City of Fredericksburg

Planning and Zoning Meeting Agenda
Wednesday, January 8, 2025 ~ 5:30 PM
New City Hall at East Campus
2818 E. U.S. Hwy. 290
Fredericksburg, Texas 78624

SHEET
PSP-01

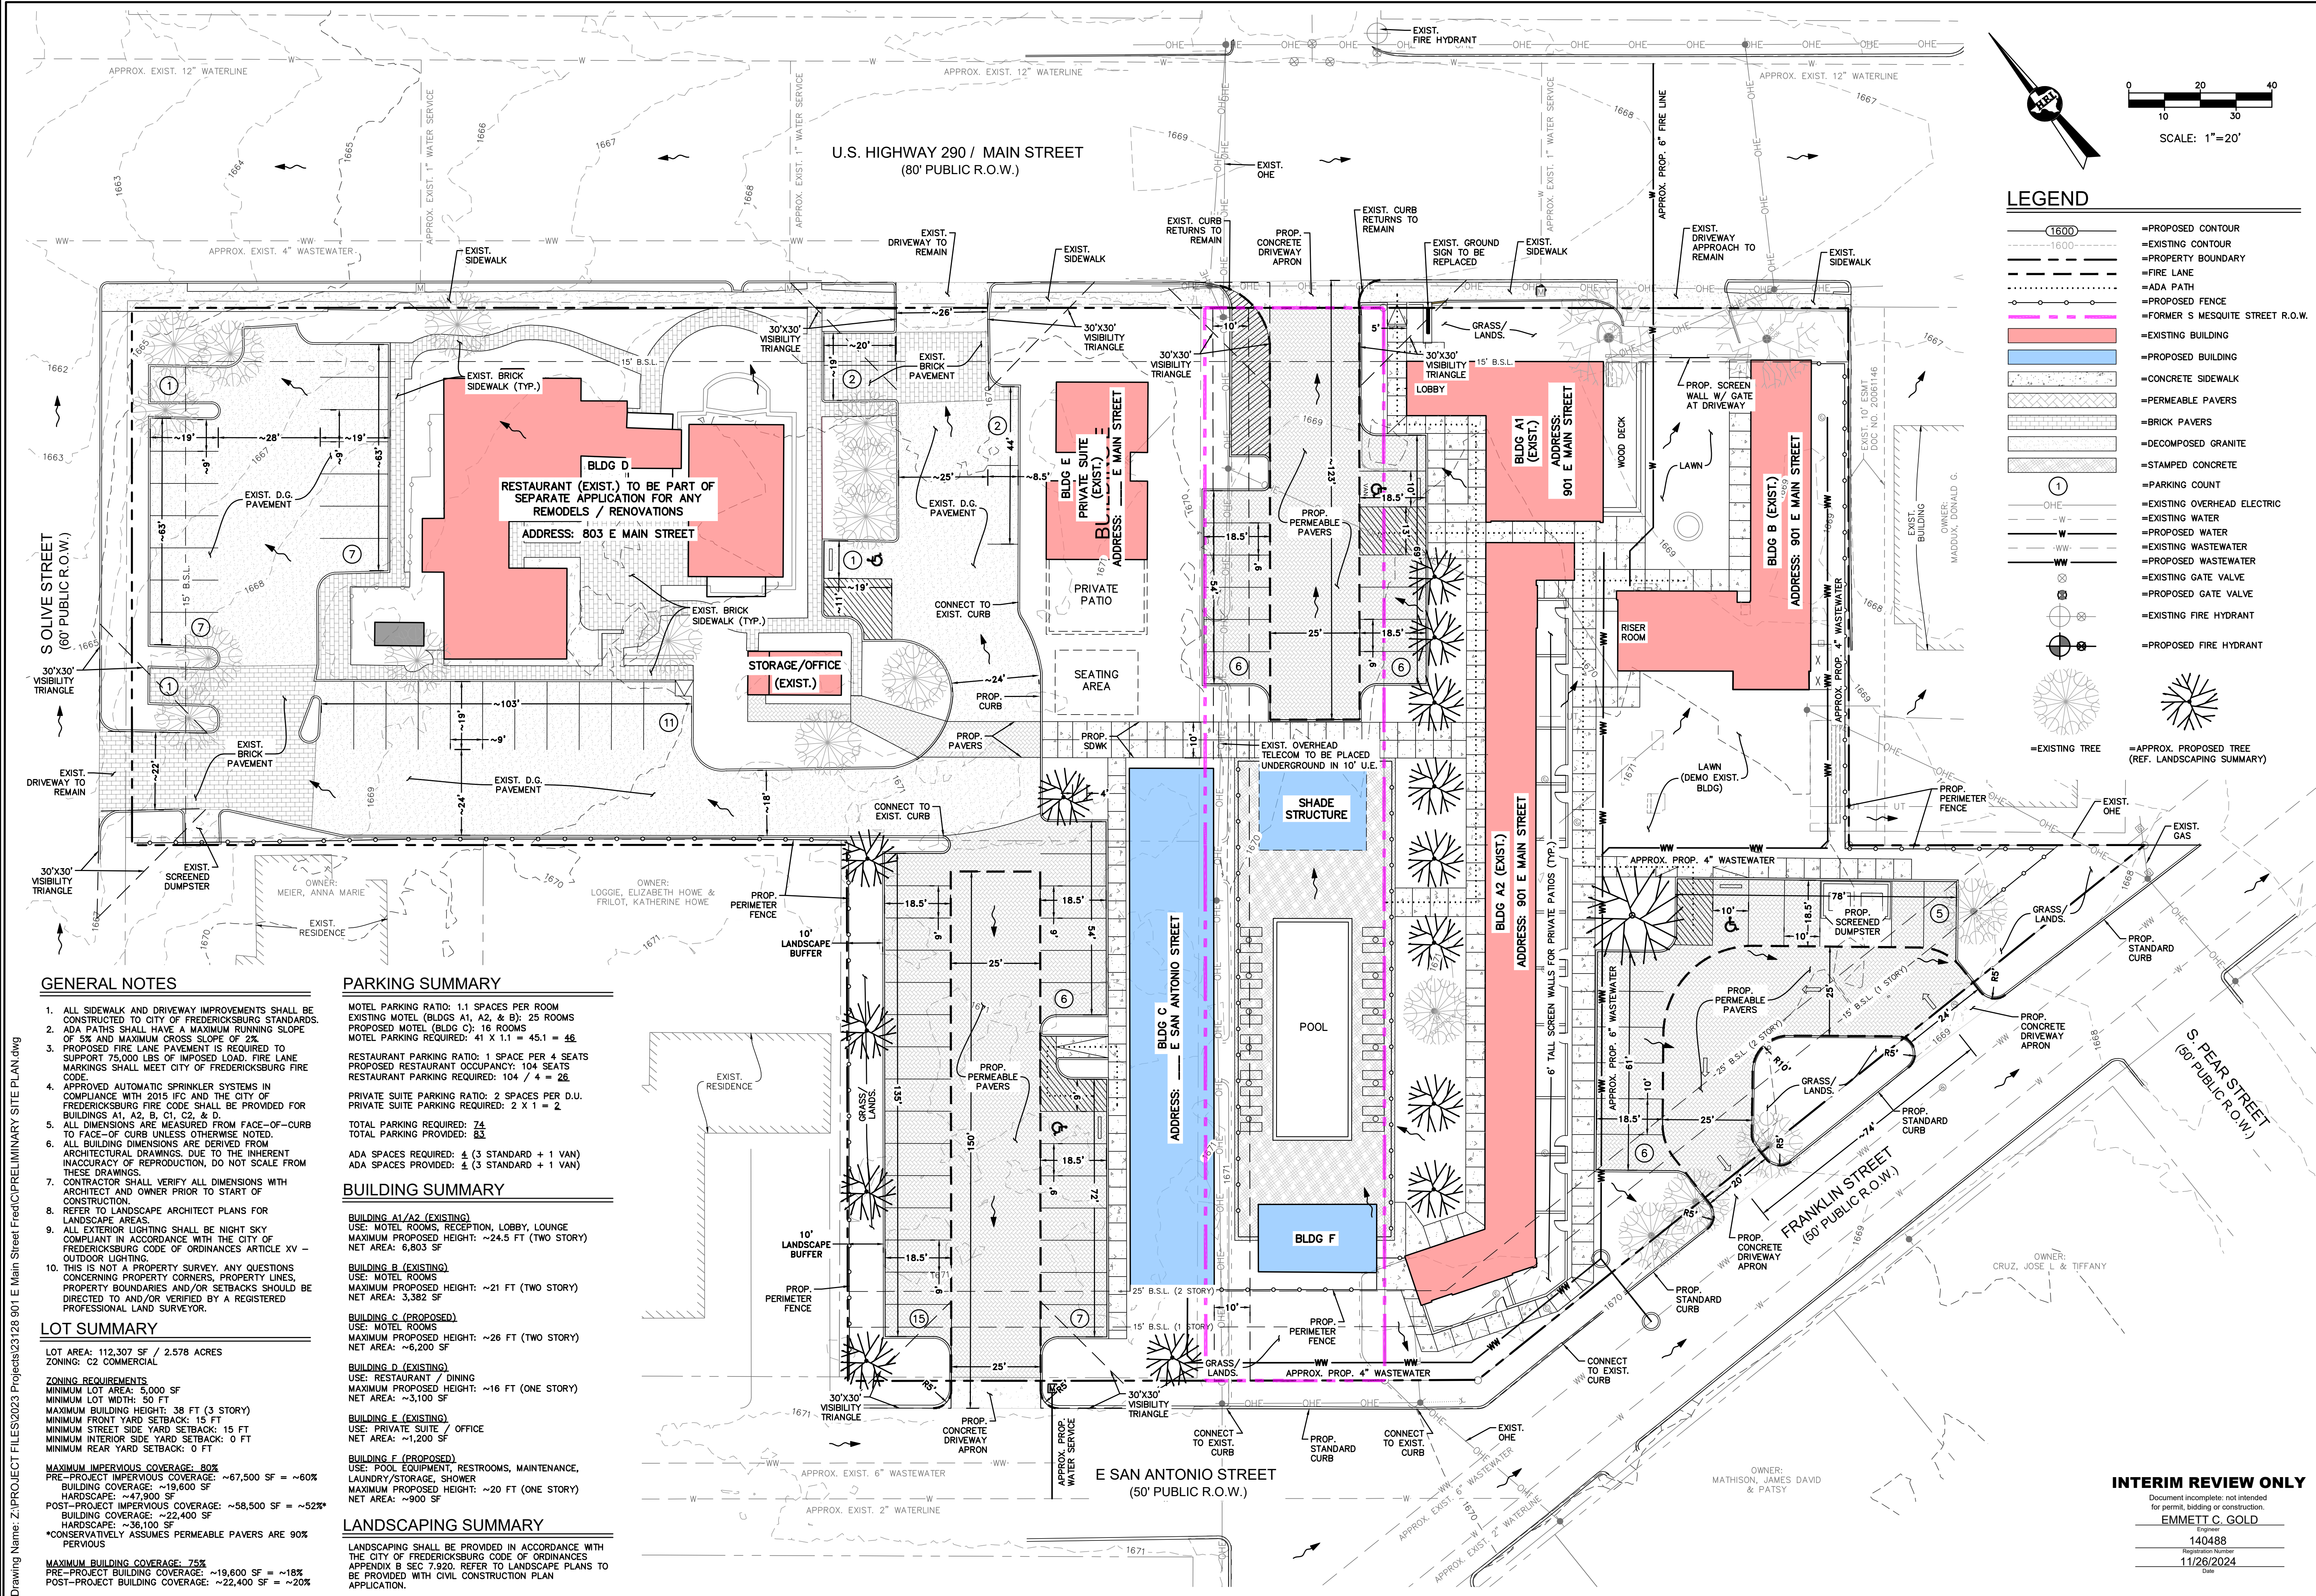
- Remove the Eastern most “driveway” which will need to be curbed and extend the sidewalk. [Sec. 7.131](#)
- Include building E in Parking summary. [Sec. 7.131](#)
- Show impervious cover calculations by building and hardscape in the Lot summary.
- Proposed dumpster location appears to be in the building setback. [Sec. 3.210](#)
- Provide a detailed landscape and screening plan per [Sec. 7.920](#) and [Sec. 7.940](#)
- Provide an addressing plan [Sec. 7.131](#)
- Identify loading areas per [Sec. 7.131](#)

- All exterior lighting will need to comply with [Article XV- Outdoor Lighting](#) and may be submitted at the time of Building Permitting
- The depth of the parking stalls should be 18.5 ft per [Sec. 7.860](#). New proposed parking shows a depth of 18 ft.
- Is there proposed signage for Franklin or East San Antonio Street? [Sec. 7.131](#)
- Update the setback requirements per [Sec. 3.210](#)
- There is a 25 ft setback for building C2 when abutting residential zoning districts [Sec. 3.210](#)
- What is the proposed height for the pool pavilion building? [Sec. 3.210](#)
- Need to verify occupancy for restaurant [Sec. 7.863](#)
- Impervious Cover is at 81 % maximum allowed is 80% [Sec. 3.210](#)

- Provide elevations and plans for all new construction to include Building C1, C2, Shade structure and pool pavilion.
- Provide a detailed landscape plan per Entry Corridor Design Standards and Guidelines [Sec 9](#).
- A minimum of a 10 ft landscape buffer will be required on San Antonio Street between the parking lot and the abutting Residential lot to the West. [Sec. 12.9](#)
- The City of Fredericksburg has adopted the Hill County Alliance [One Water](#).
- Loading/Unloading areas shall be clearly identified by installing no parking signs and/or striping of the space. The areas must be in the rear or the sides of the building and shielded so that they are not visible from the street. [Sec 11.1](#)

- This project will require the submission and review of civil construction plans.
- Please close the unused drive fronting Main Street.
- Please note that decomposed granite is considered impervious.
- The pool can be excluded from impervious cover calculations.
- Please show private utility easements for water and sanitary sewer lines
- All driveways within public right-of-way must have City standard concrete approaches. Grass paved or brick approaches are not permitted.
- Please show the location of visibility triangles at all driveways.
- Please note aisle width and parking space minimums in the City Code of Ordinances. Make sure all parking spaces are compliant.
- Sidewalks fronting along TxDOT ROW must be improved to TxDOT standard 5' width with landscape buffer or 6' abutting back of curb.

1. Remove the Eastern most “driveway” which will need to be curbed and extend the sidewalk. Sec. 7.131
Response: The eastern driveway is intended to be kept in place for special events. In normal operating conditions, the eastern driveway will have a screen wall with closed gate at the building setback. This is currently being coordinated with TxDOT.

2. Include building E in Parking summary. Sec. 7.131
Response: Building E has been added to the parking summary on the site plan.
3. Show impervious cover calculations by building and hardscape in the Lot summary.

Response: Impervious cover calculations have been listed by building and hardscape in the lot summary.
4. Proposed dumpster location appears to be in the building setback. Sec. 3.210

Response: The dumpster location has been relocated outside of the building setback.
5. Provide a detailed landscape and screening plan per Sec. 7.920 and Sec. 7.940

Response: A draft landscape plan has been provided with this comment response package, with a detailed landscape and screening plan to be provided with the civil construction plan application.

6. Provide an addressing plan Sec. 7.131
Response: Our understanding is that addressing will be provided by the City. We have shown existing addresses for Buildings A and B (901 E Main Street) and Building D (803 E Main Street). We would propose a separate address for Building E (private suite), along with a separate address for Building C as it fronts on E San Antonio Street. We are open to City input on how they would like these to be addressed.
